Title	DRAWN BY: vk3pe	
Size: A3	Date: 17-Dec-2018 Time: 13:55:47	Sheet 1 of 1

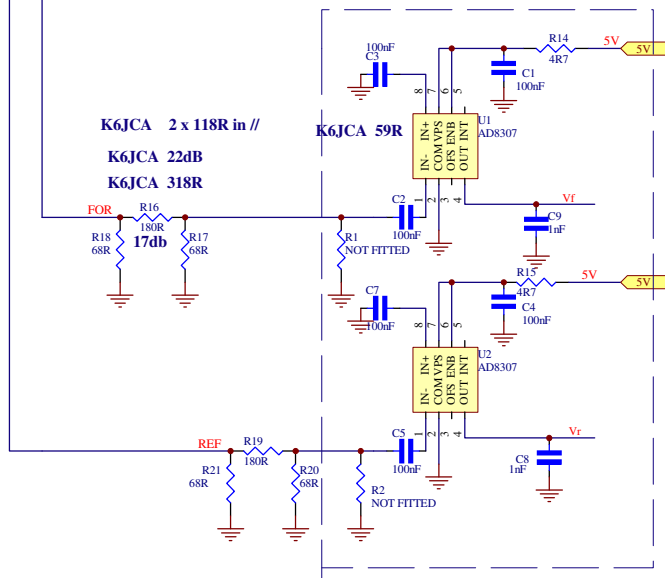
NOTE 3) ON CONTROL BOARD SCH:-
 ** NOTE R3 & R4 on control board should be changed from 10k to 1M or the slope of the AD8307 is flected

250617 FOR PCB VERSION 2.1a
 add 1nf cap on Vf & Vr
